PROPOSED IMPROVEMENT
BRIDGE PROJECT
TOWN OF ENOSBURG
COUNTY OF FRANKLIN
BOSTON POST ROAD T.H.2 CLASS 2 BRIDGE NO: 48

RECORD PLANS	
CONTRACTOR:	A.L. ST. ONGE CONTRACTOR, INC. - MONTGOMERY, VT
RESIDENT ENGINEER:	SCOTT WHEATLEY
CONSTRUCTION BEGAN:	JUNE 12, 2014
CONSTRUCTION COMPLETE:	SEPTEMBER 24, 2014
RECORD PLANS BY:	SCOTT WHEATLEY & JENNA HYDE
I HEREBY CERTIFY THAT ALL THE CONSTRUCTION REQUIRED BY THIS SET OF DRAWINGS HAS BEEN ACCOMPLISHED AS INDICATED HEREIN.	
BY	<i>Scott Wheatley</i> RESIDENT ENGINEER
DATE	1-6-2016
NOTE: Any further information concerning final quantities, amounts or other details relative to this project may be found at Central Files in the electronic archives.

STATE OF VERMONT AGENCY OF TRANSPORTATION TOWN OF ENOSBURG BOSTON POST ROAD T.H. 2 CLASS 2, BRIDGE NO: 48		
STATE	COUNTY	CONTROL NO.
VT	FRANKLIN	N/A
PROJ. NO.: BRO 1448 (40)		
DYNAMIC RUBBER: LAMINATED BEARING PADS		
1501 ROCKY RIDGE ROAD P.O. BOX 2159 ATHENS, TEXAS 75751		
SCALE: NONE	DRAWN BY: CV DATE: 3/7/14	CHECKED BY: ELS DATE: 3/11/14
SHEET 01 OF 1		JOB NO.: 12341
CUSTOMER: A.L. ST. ONGE CONTRACTOR INC.	DRAWING NUMBER 12341-GN1	REV. 1

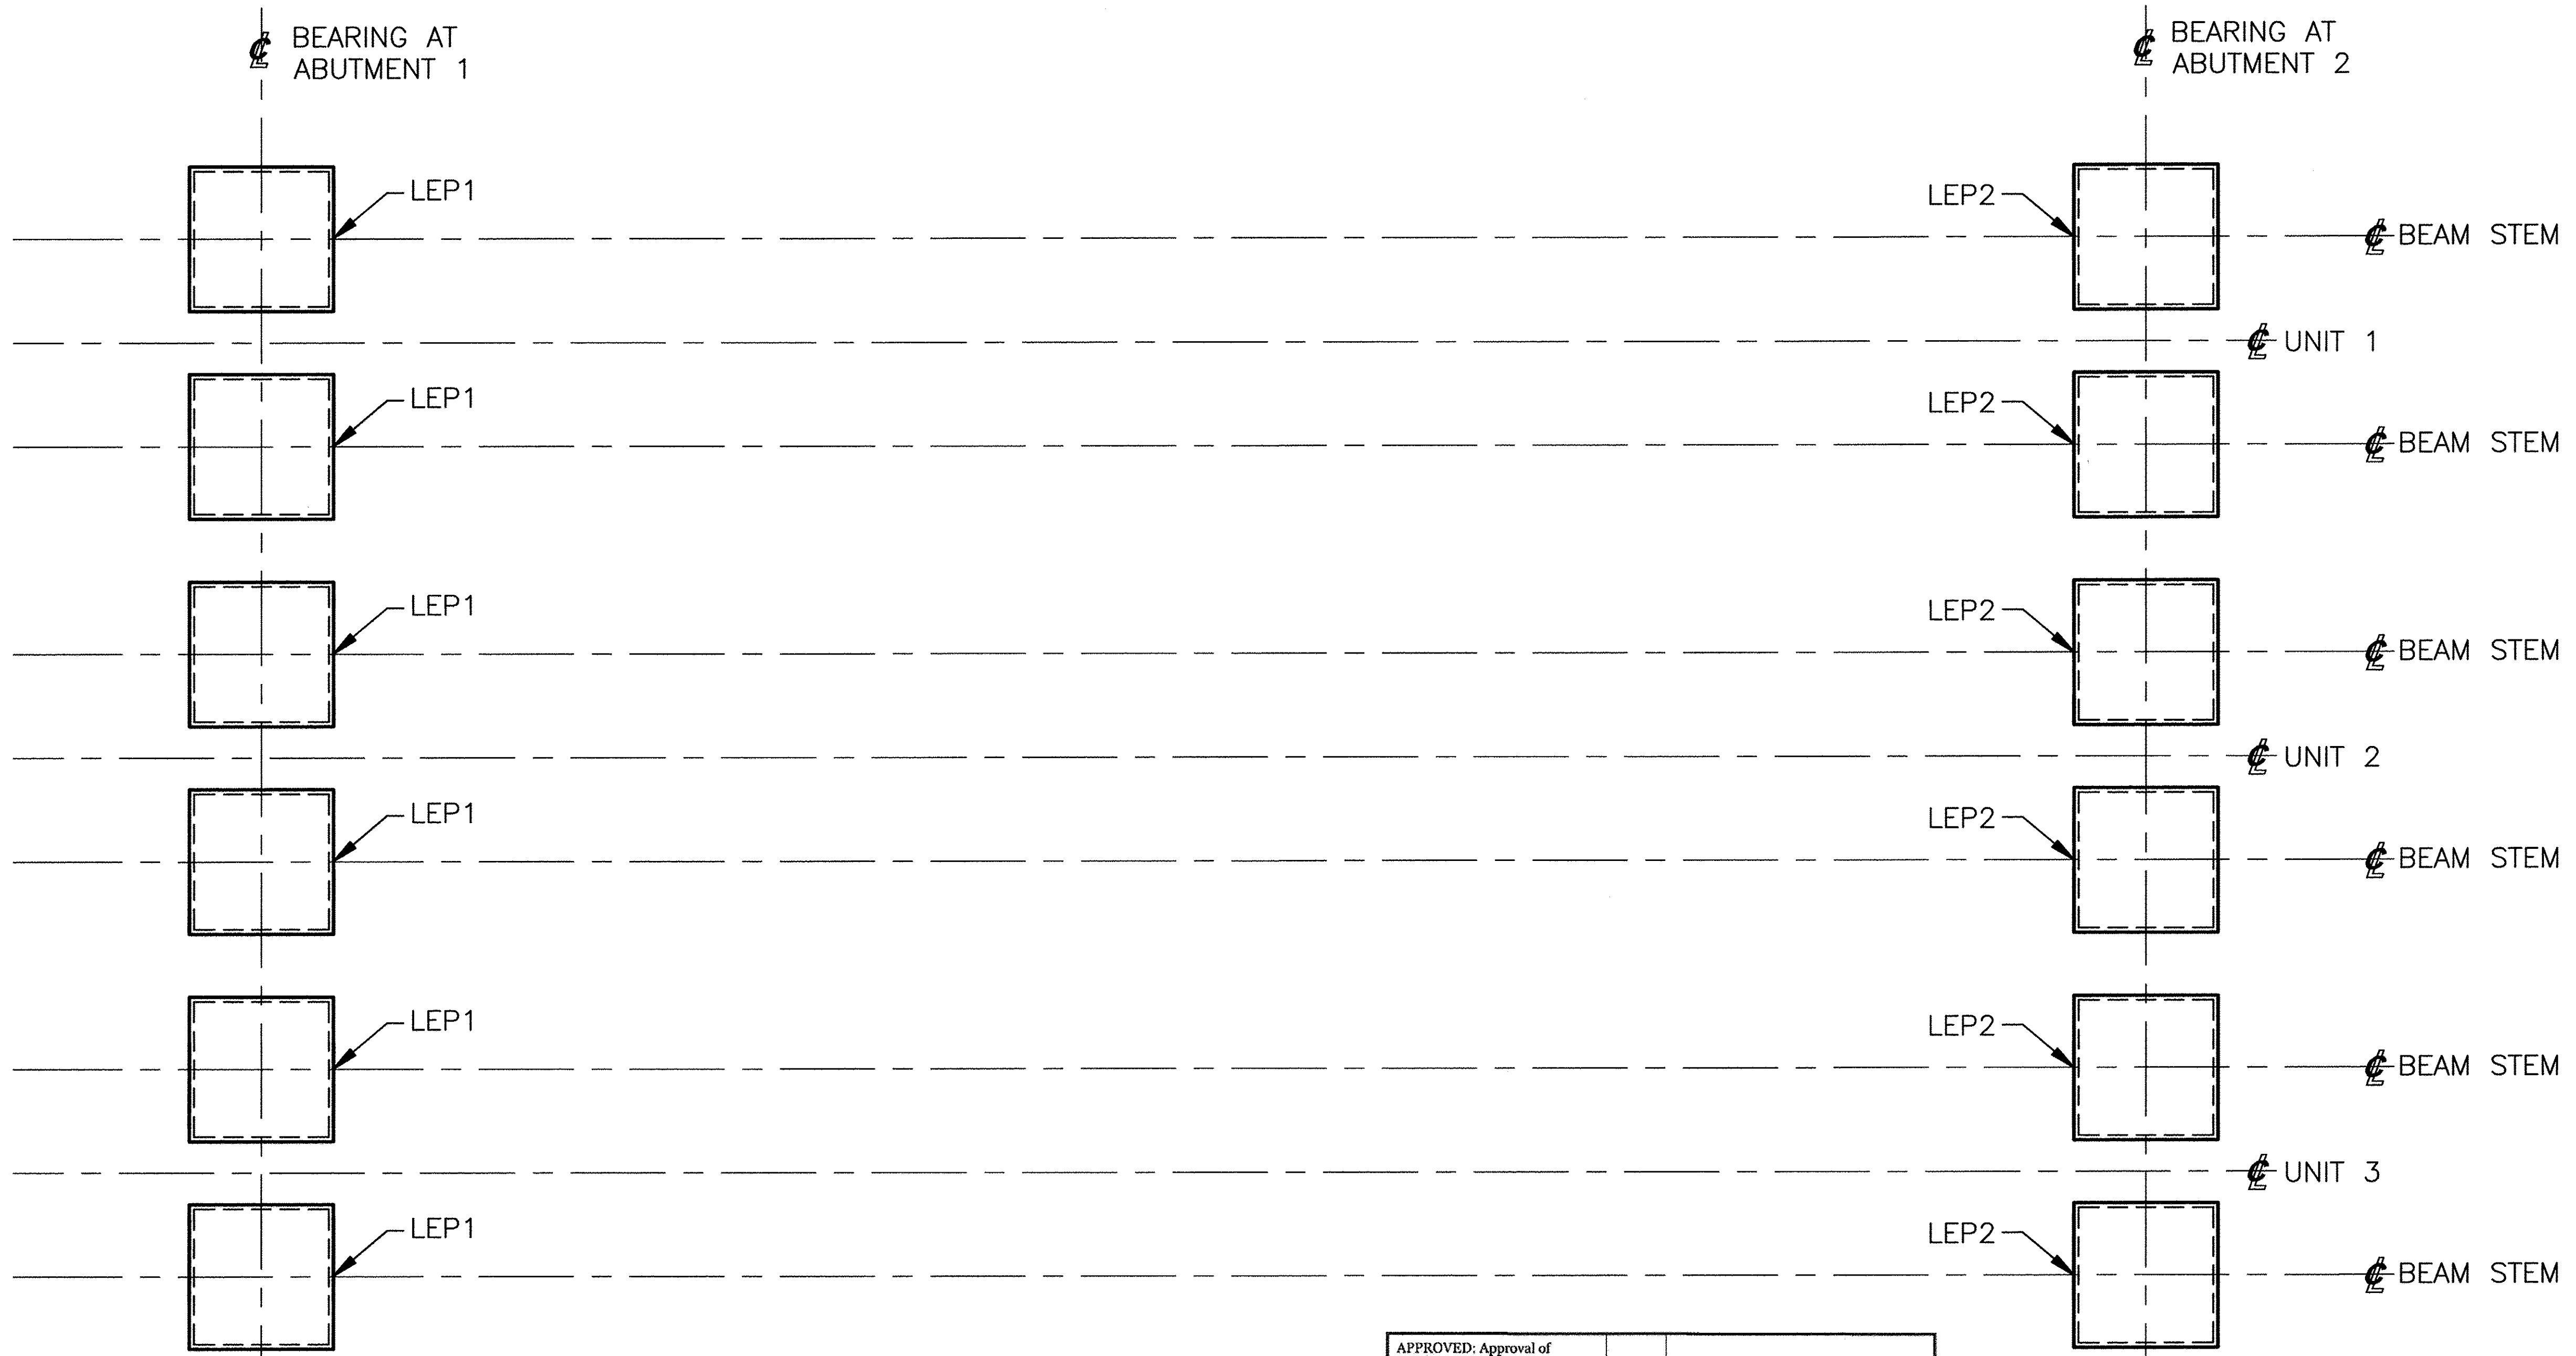
REVISED ELASTOMER TYPE FROM NEOPRENE TO NATURAL RUBBER PER RFI	JG	5/27/14	SL	5/27/14
REV.	DESCRIPTION	BY	DATE	CK'D	DATE

#### WEST RAIL ELEVATION

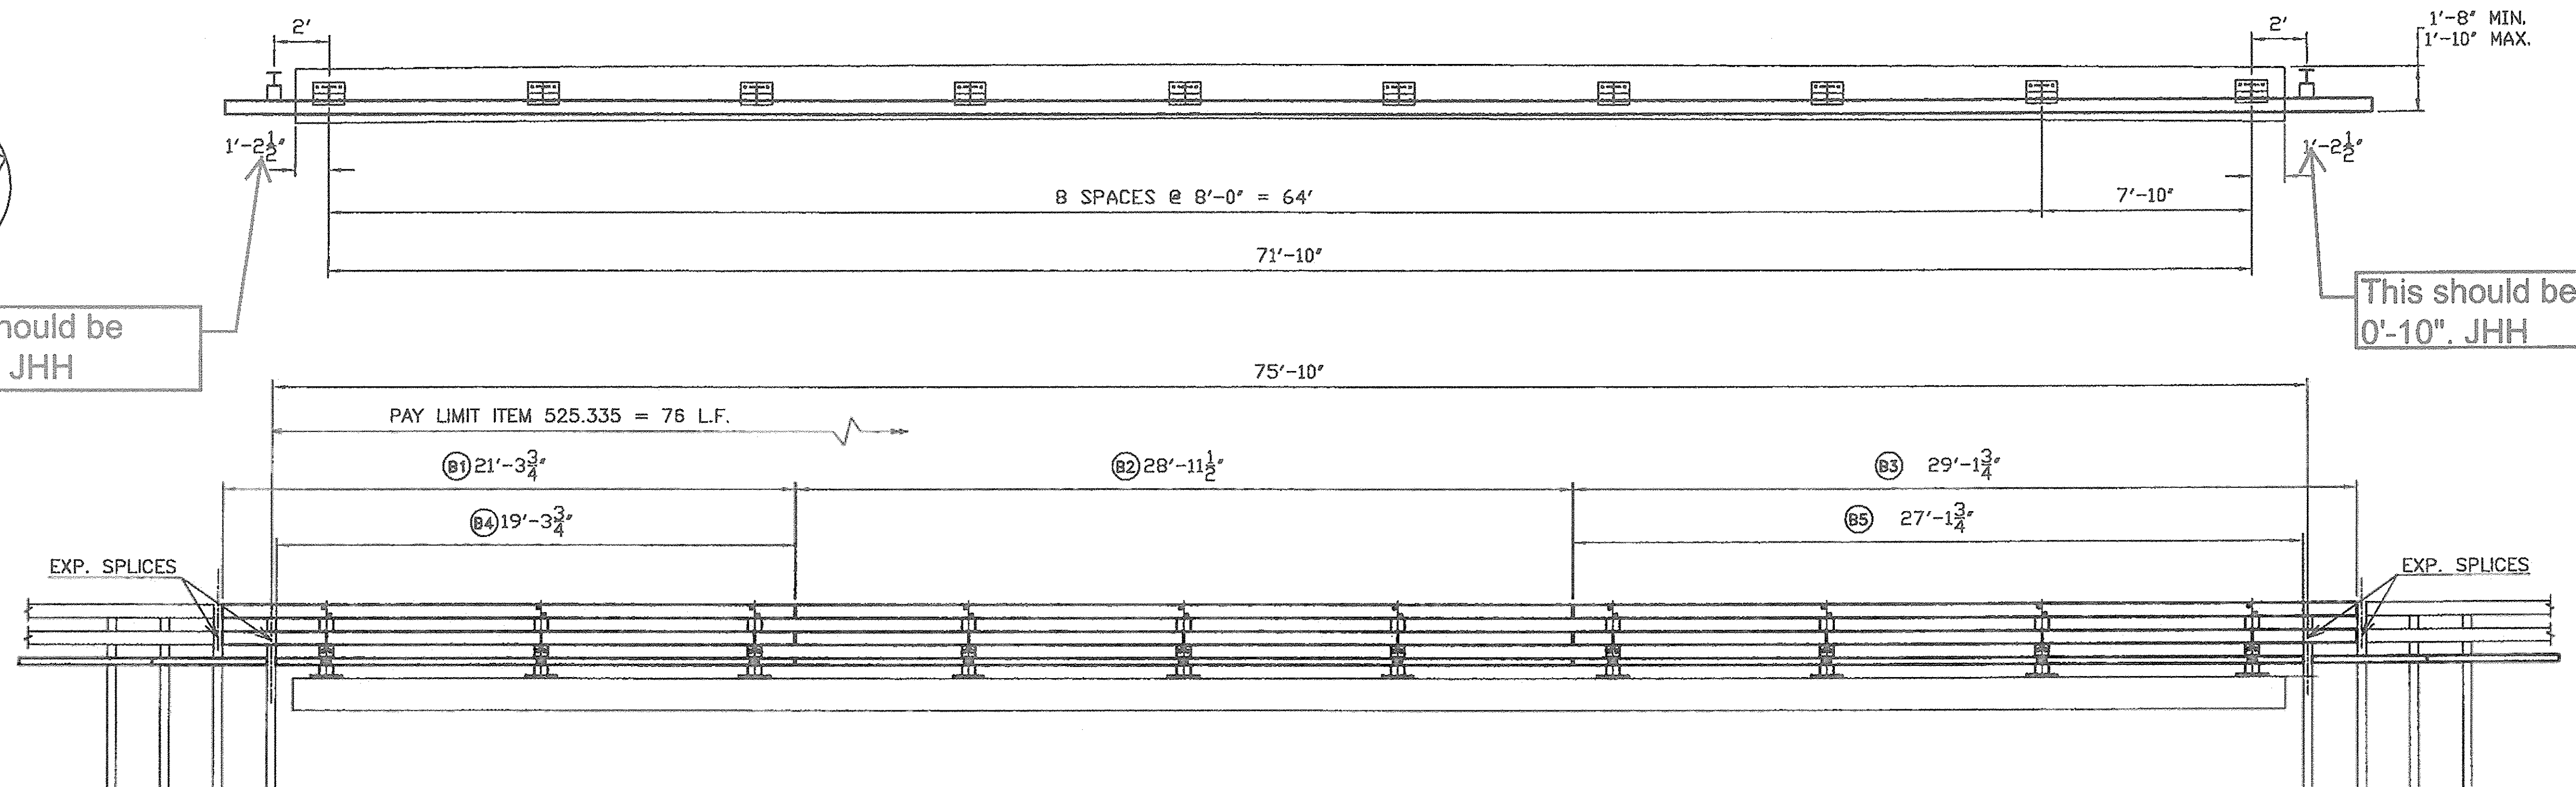
This should be  
0'-10". JHH
